# *Preliminary Alternatives Summary*

## **Airside Alternatives Introduction**

**From:** House, Timothy A (FAA) <Timothy.A.House@faa.gov>  
**Sent:** Friday, June 7, 2024 1:08 PM  
**To:** Tony Beach; David Miller; Samantha Peterson  
**Cc:** Thorsen, Valerie (FAA)  
**Subject:** Summary Presentation for PAC Meeting #6

FIGURE 5: AIRSIDE ALTERNATIVE 5  
CHANGE TO B-II, SHIFT AND EXTEND RUNWAY NORTH

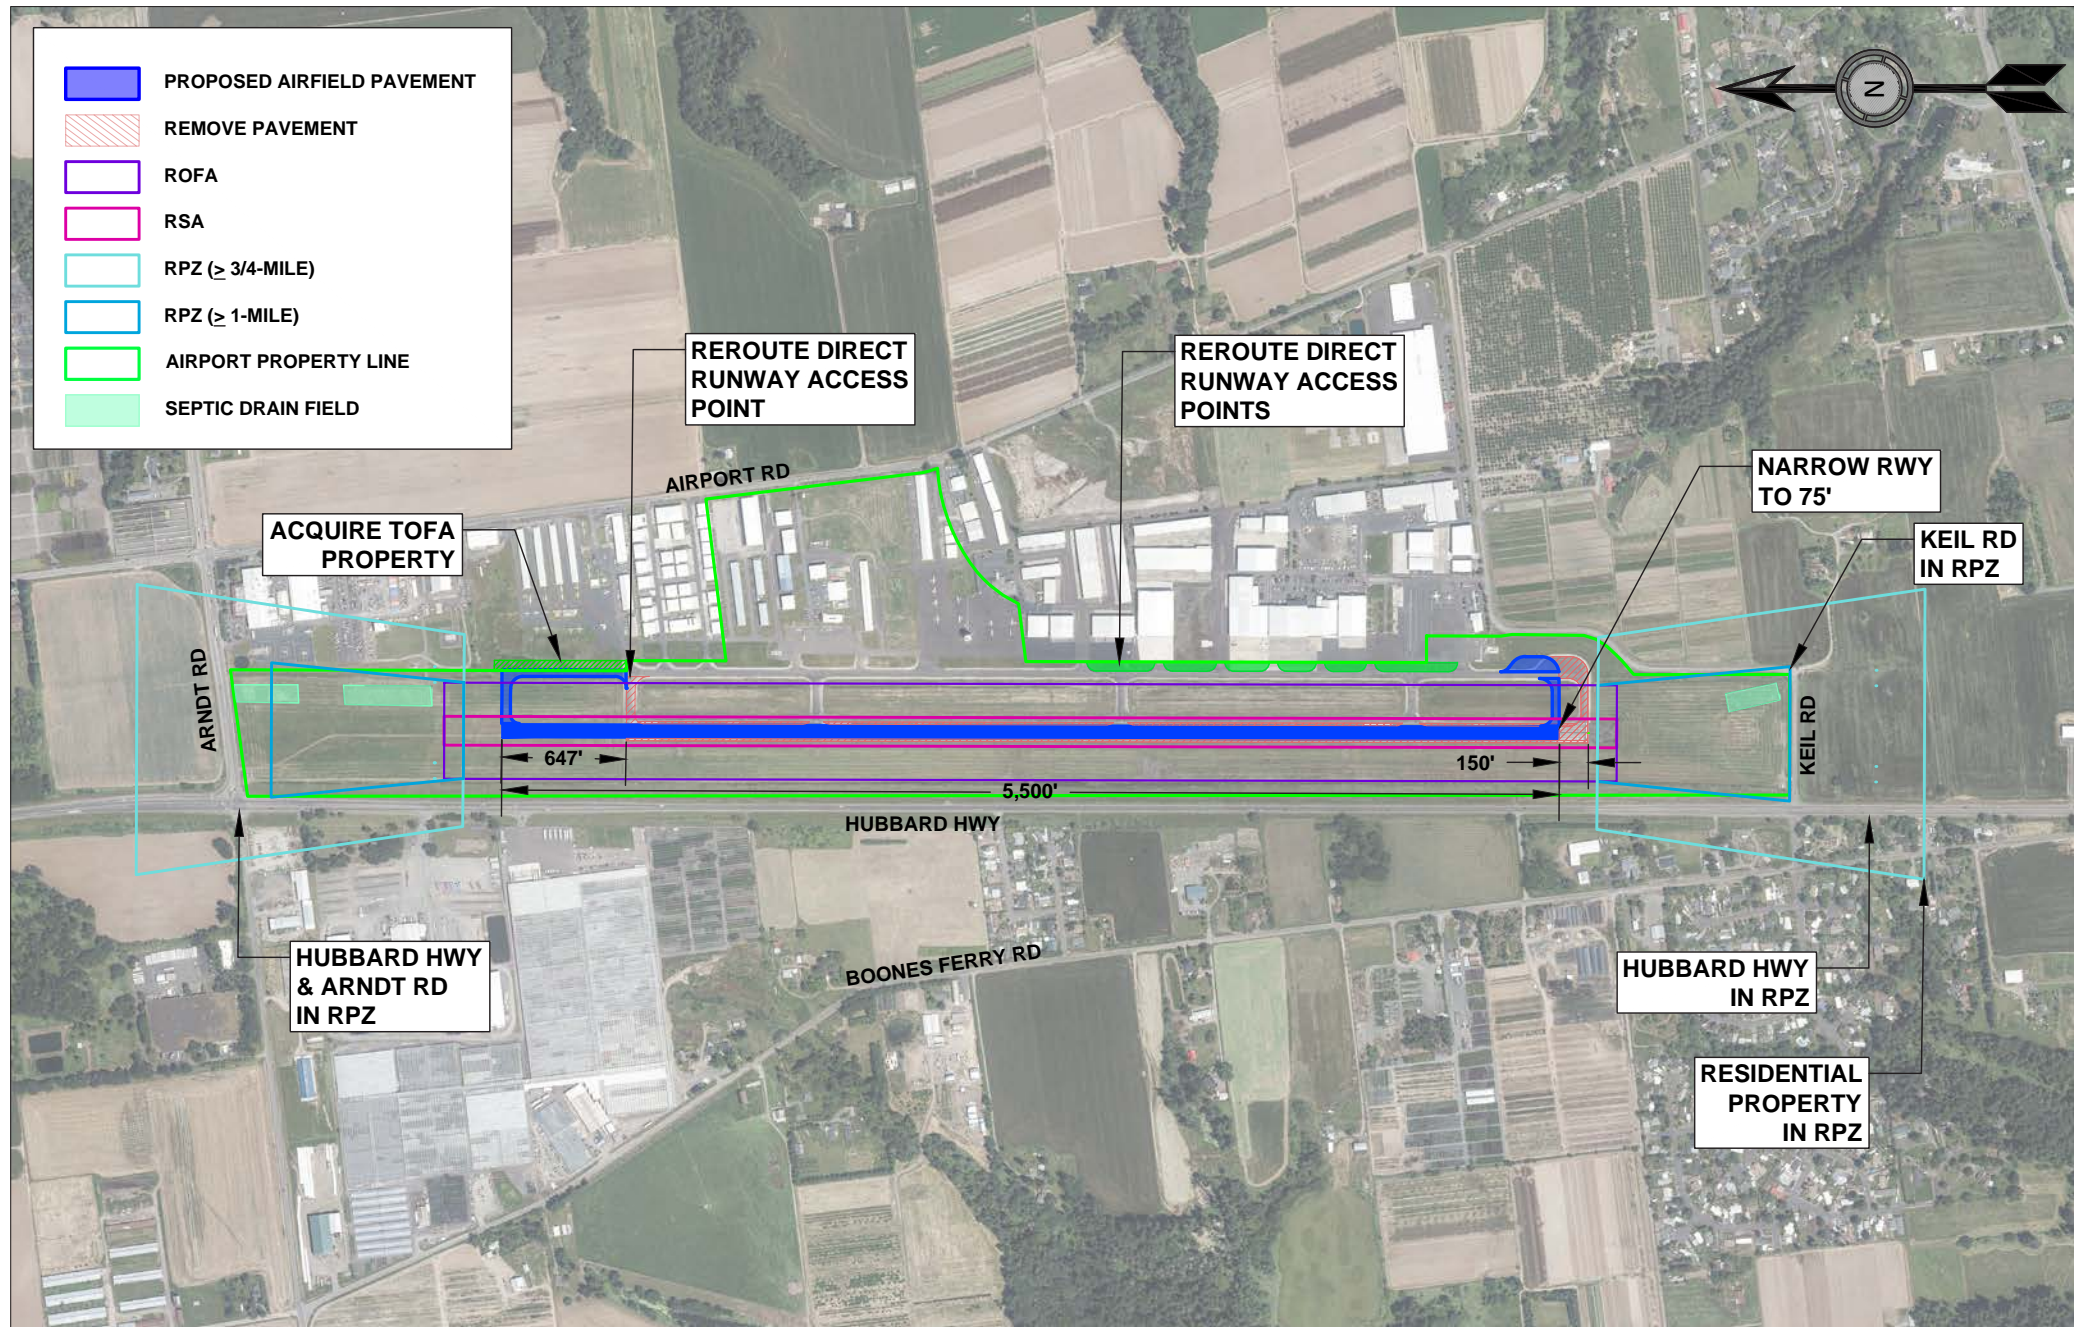
As I was reviewing the material for the upcoming PAC meeting I shared the alternatives that were included in the Preliminary Alternatives Summary with other FAA staff. Based on the fact that the approved critical aircraft is C-II we do not see that the B-II alternatives have a path forward. Operations would have to reduce to below C-II normal use in order for the B-II alternatives to be considered. The approved forecast does not indicate that is likely to occur.

It is our recommendation that they be removed from the presentation since they do not present a solution that meets current standards. This will allow more time to discuss and further develop alternatives that meet current standards.

# AFTER COORDINATION WITH FAA, B-II ALTERNATIVES ARE NOT VIABLE AND WILL NOT BE CONSIDERED FURTHER
